Hexham Long Term Train Stabling Facility Modification 2 (SSI-6090-Mod-2) – Project Amendment

The purpose of this submission is to request that the scope of the modification to the approved State Significant Infrastructure Project for the Hexham Long Term Train Support Facility (LTTSF Project) (SSI-6090 – Mod 2) be amended prior to finalisation of the assessment. This modification is for the development of a depot, warehouse and wagon storage (the Modification Proposal) at the LTTSF, and has been submitted under Section 5.25 of the *Environmental Planning and Assessment Act 1979* (EP&A Act).

Proposed Amendments

SITE PLAN

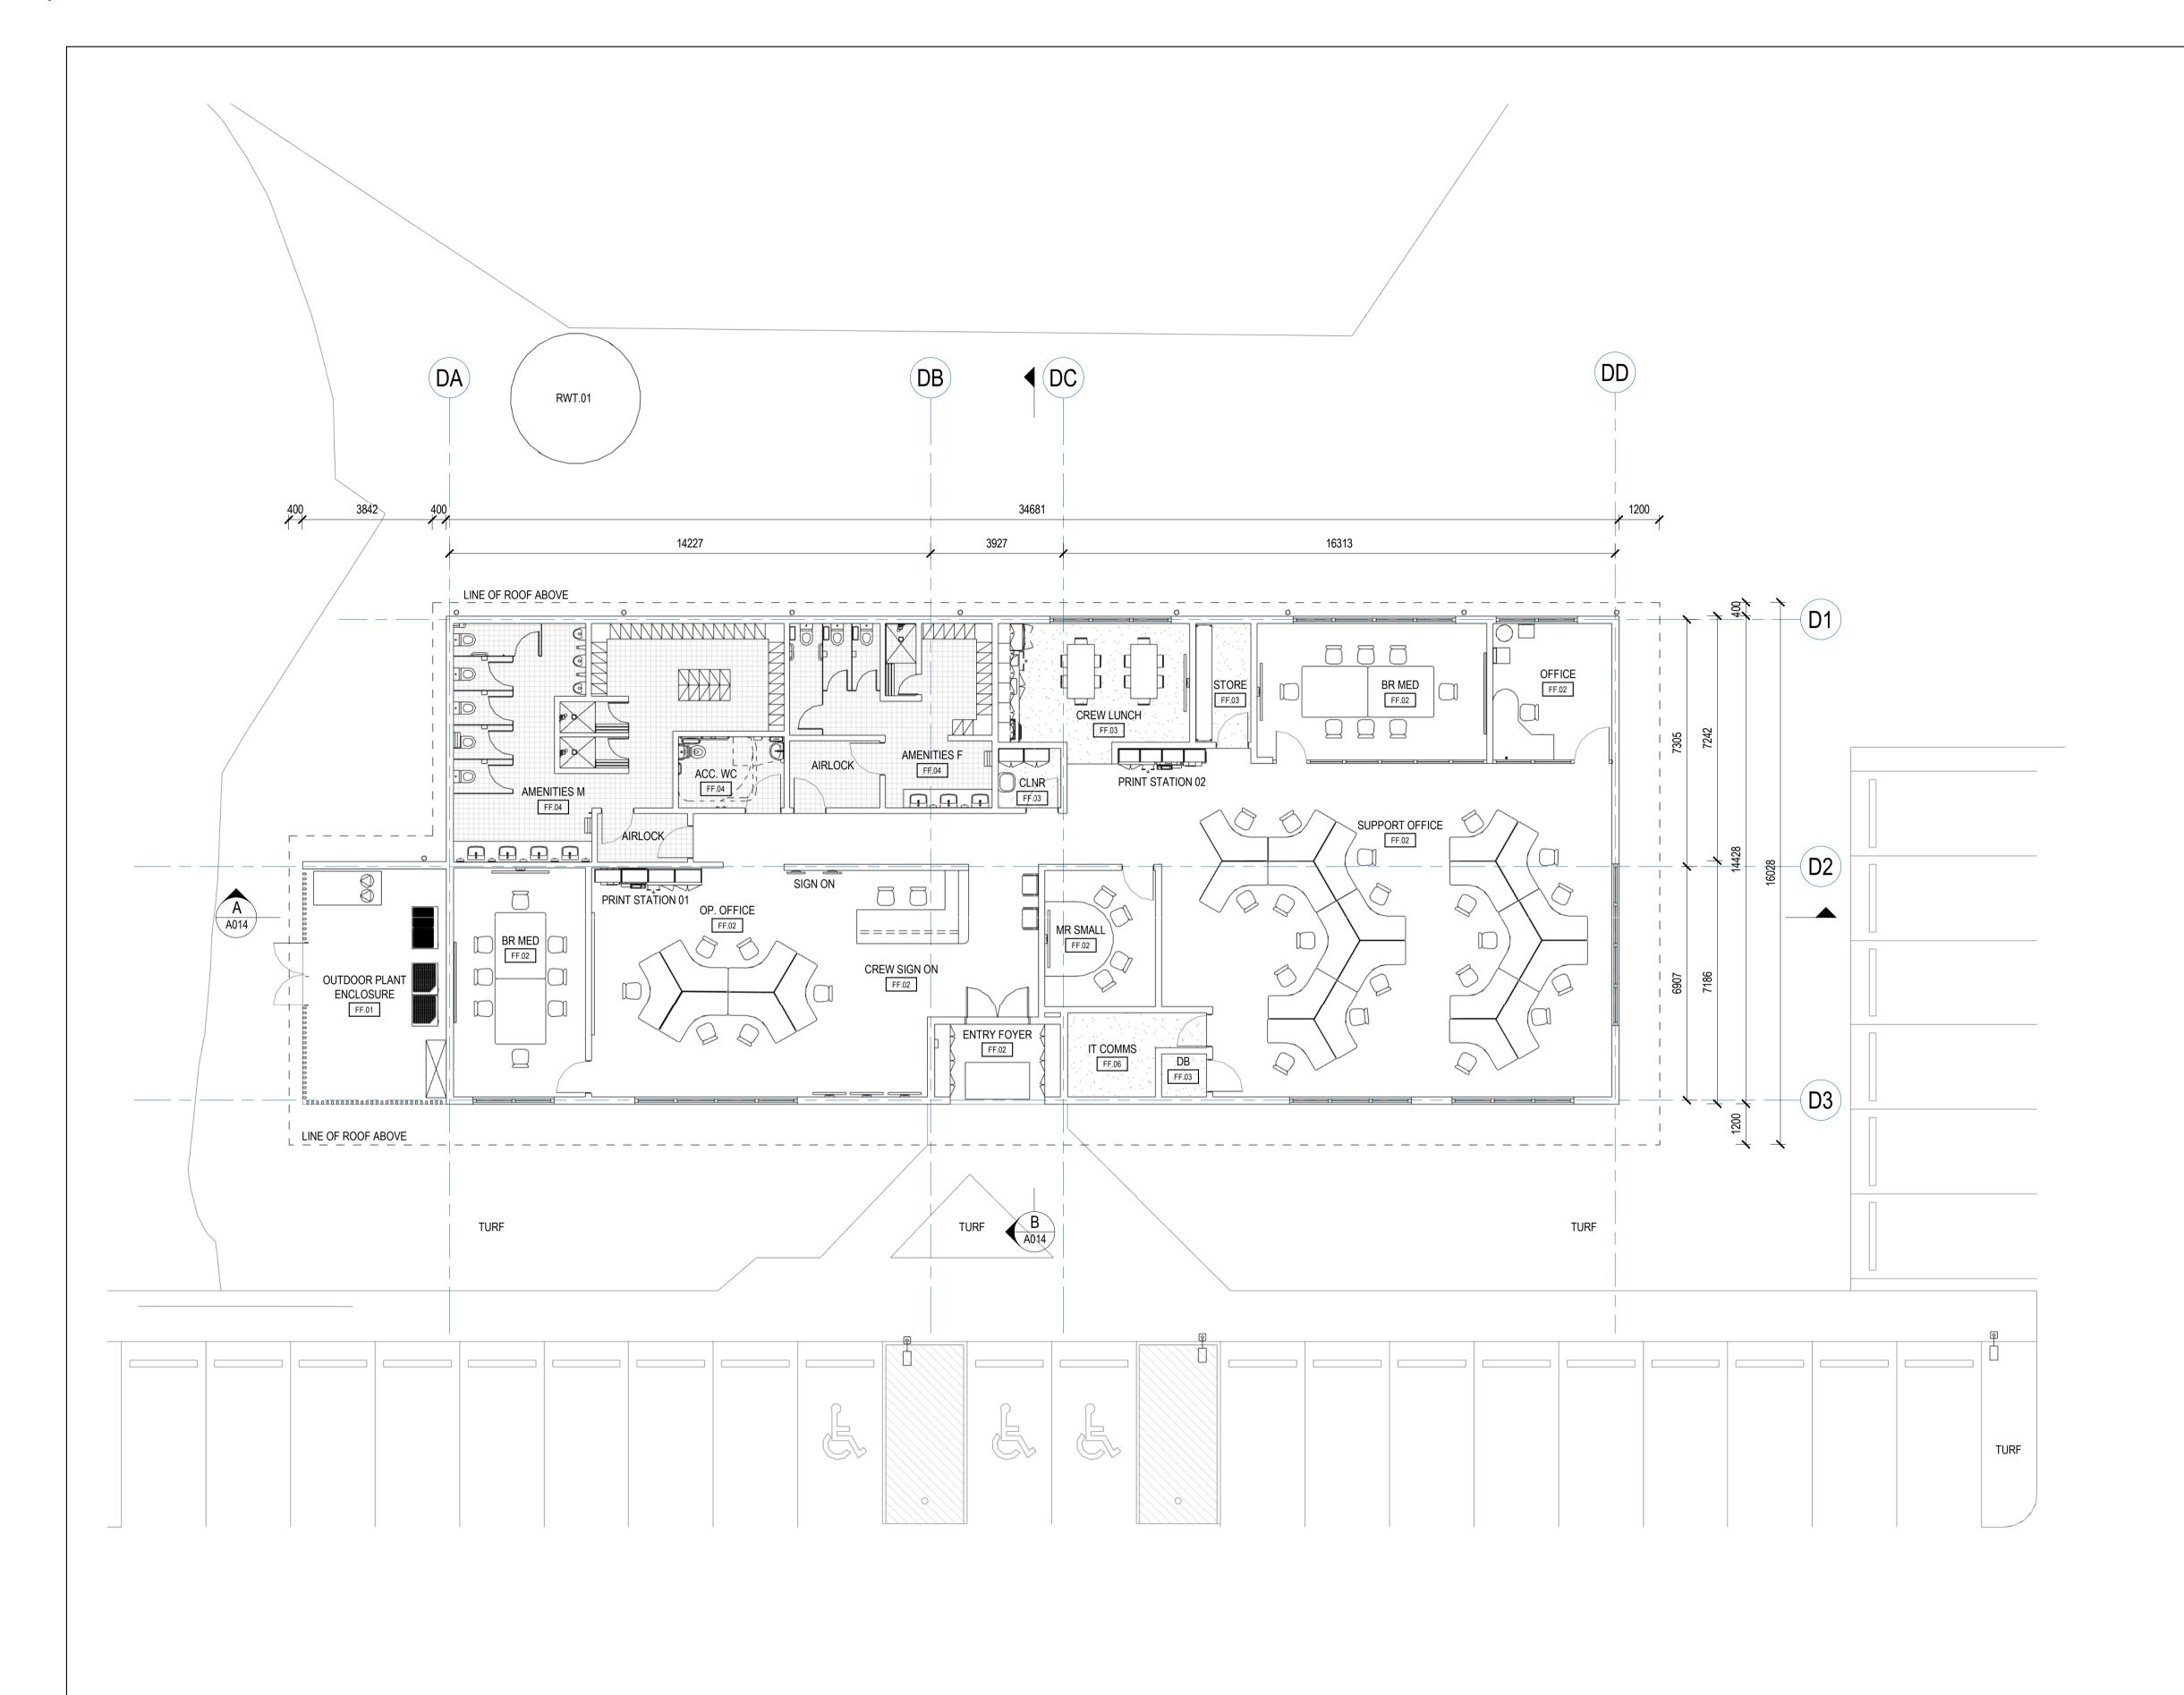
- The car parking area will be simplified, rationalised, and the total extent of hardstand reduced, whilst providing for 71 car parking spaces, including 3 accessible spaces, and 5 motorcycle parking spaces. Landscaping throughout the car parking area has been modified as part of the revised car park design, and a revised Landscaping Plan is provided at **Attachment B**.

DEPOT - GENERAL ARRANGEMENT PLAN 70% DETAILED DESIGN

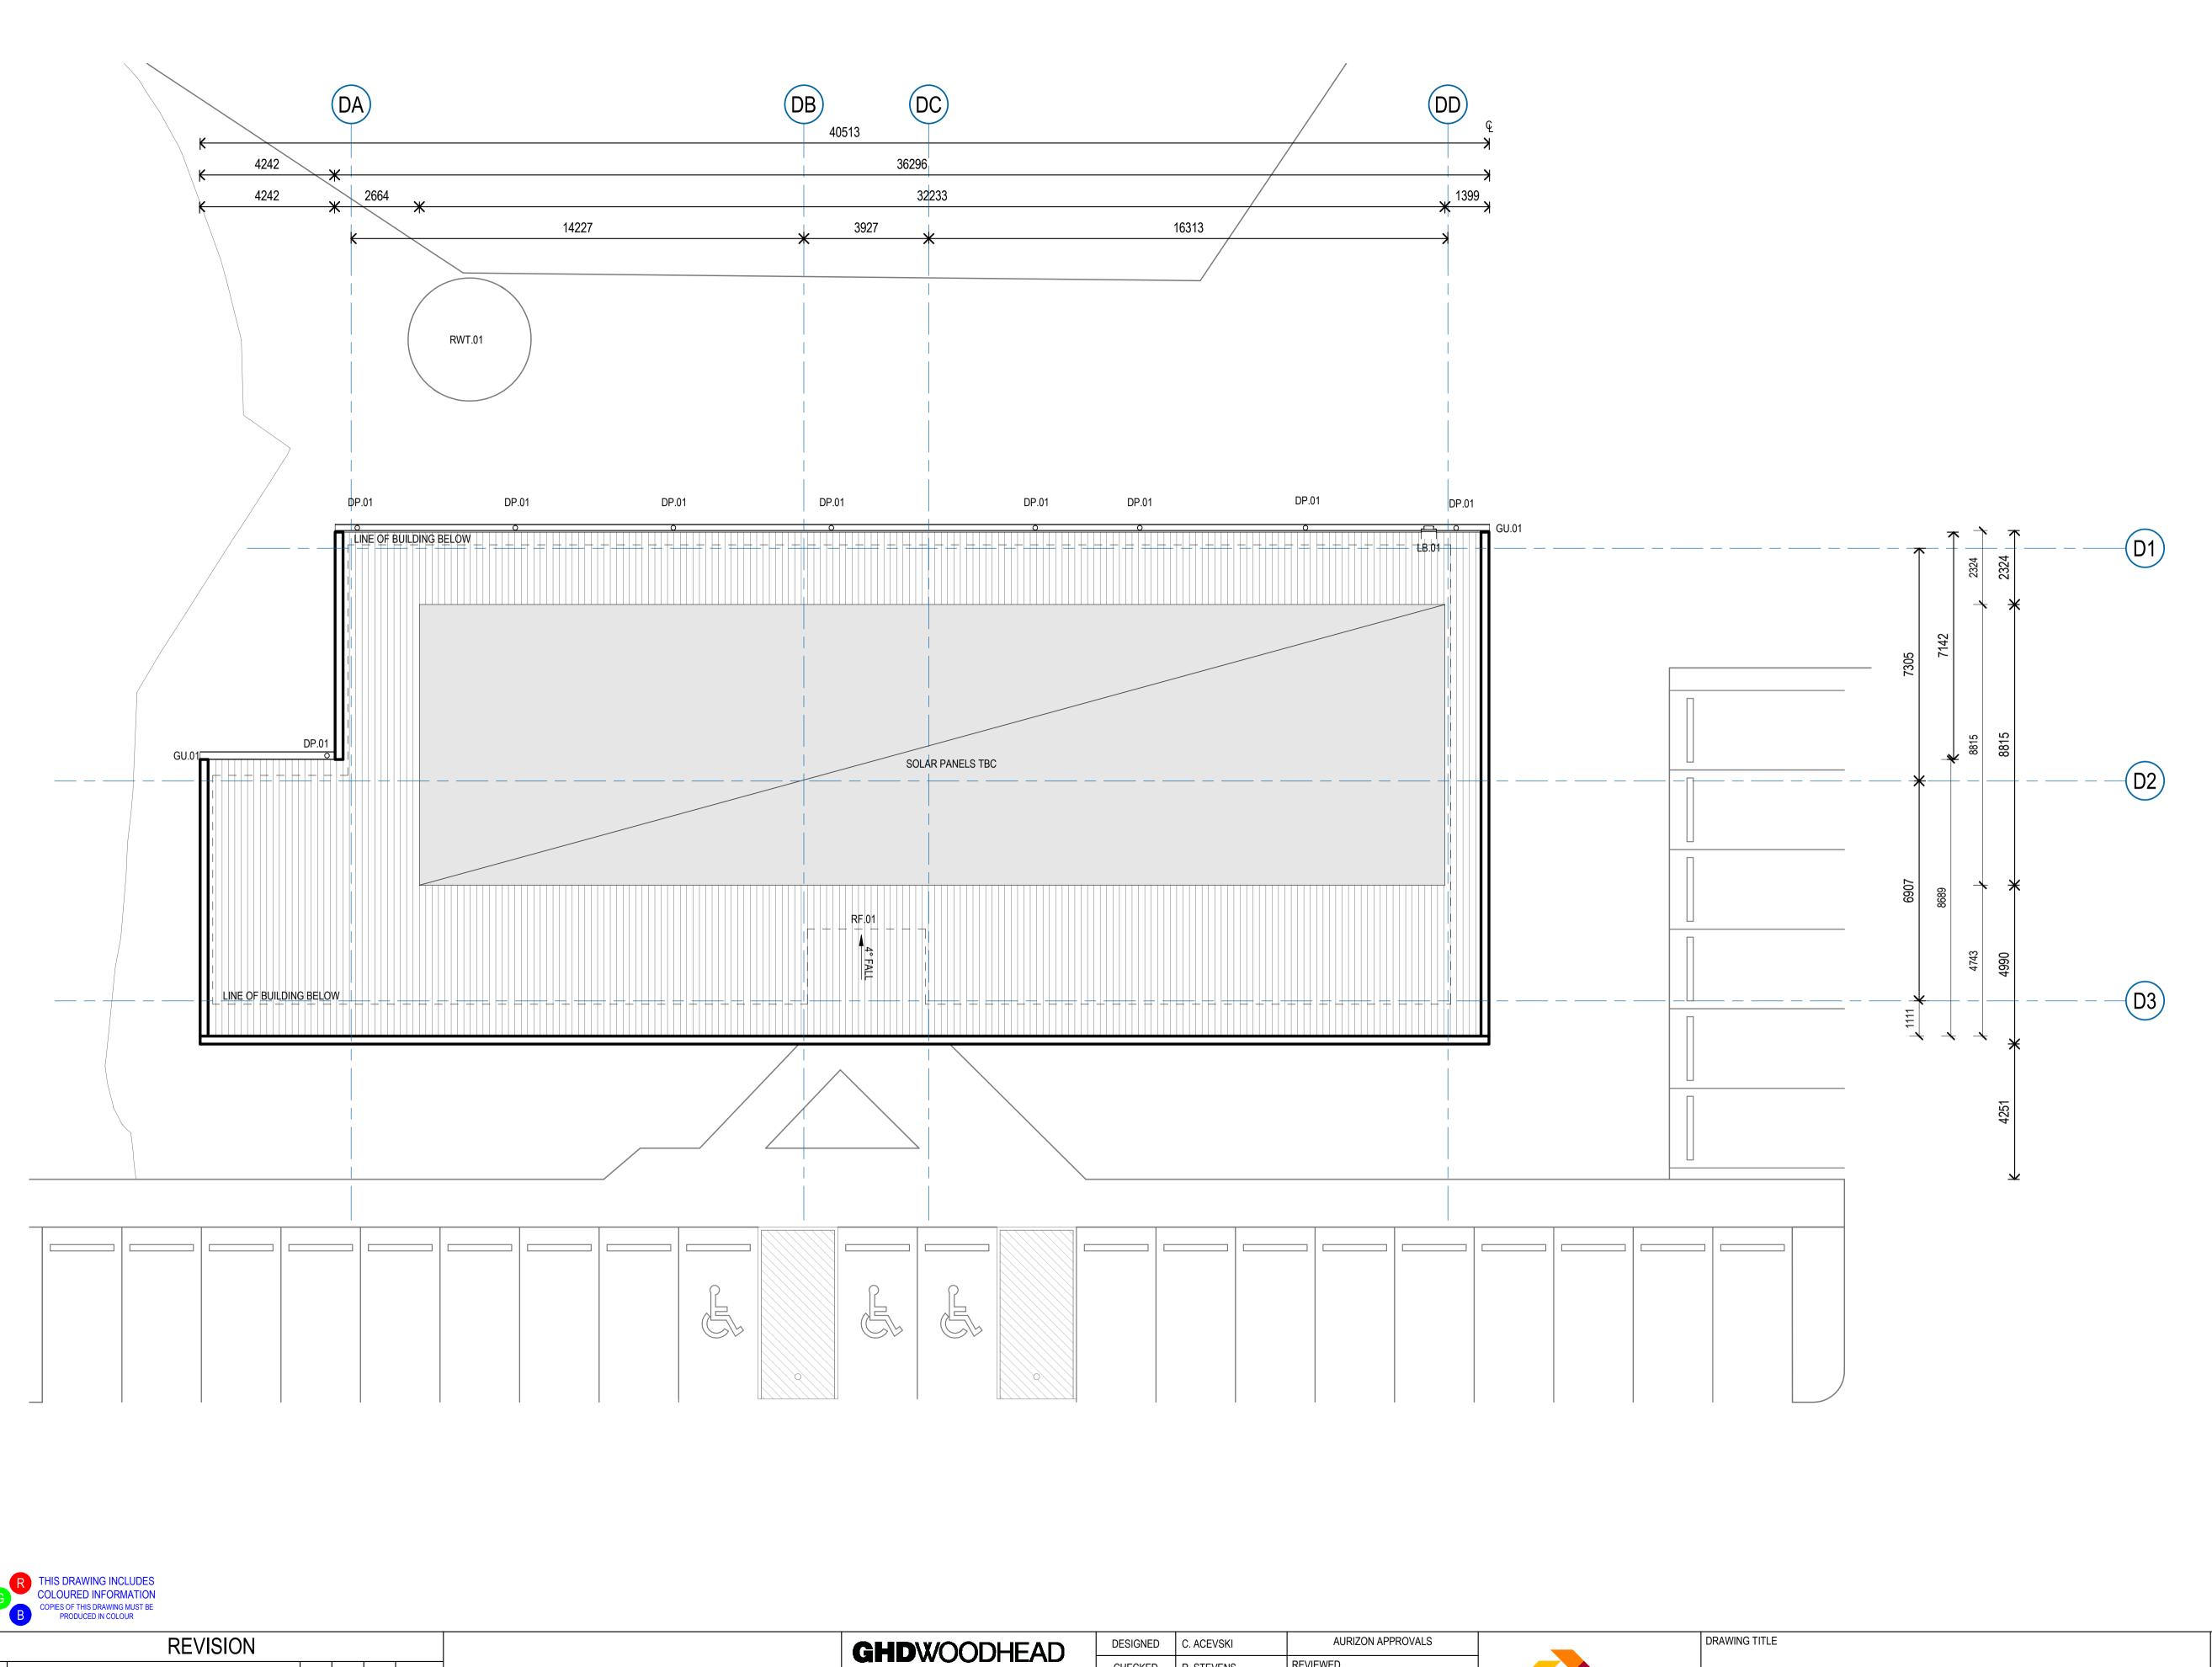
- The depot / office building will be reduced to 500m² with a simplified entry foyer. The height of the building will also be reduced to approximately 4m. Changes to the materials and finishes, although the building will still be finished with a combination of fibre-cement sheeting and colourbond steel.

WAREHOUSE - ELEVATIONS

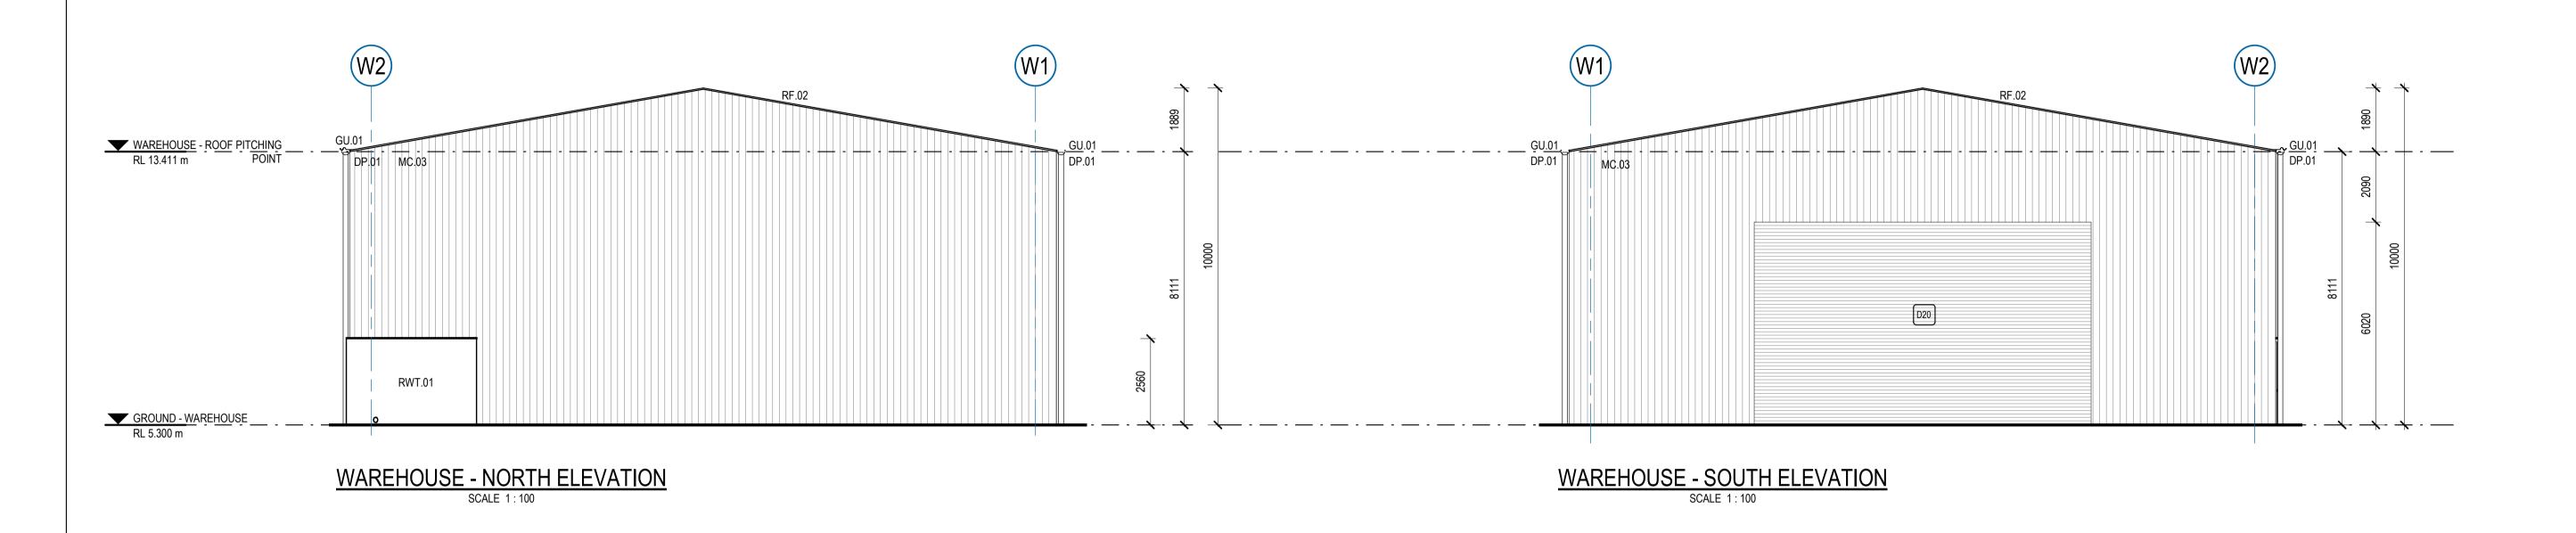
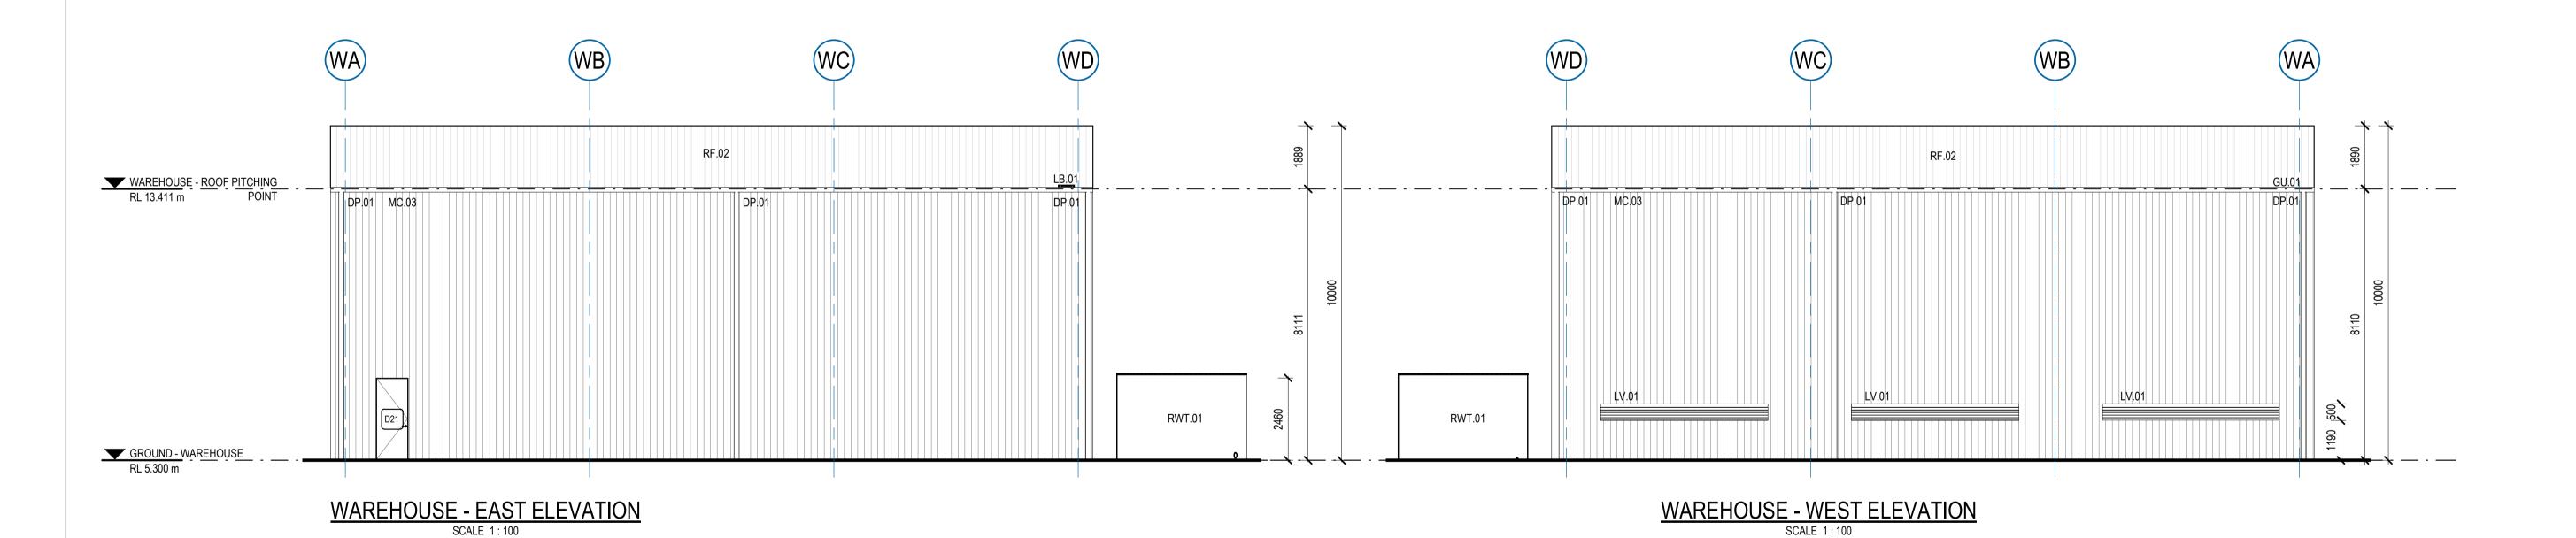
- The warehouse will be reduced in height from 12.3m to 10m. Changes to the materials and finishes, although the warehouse will still be finished predominantly in colourbond steel. .
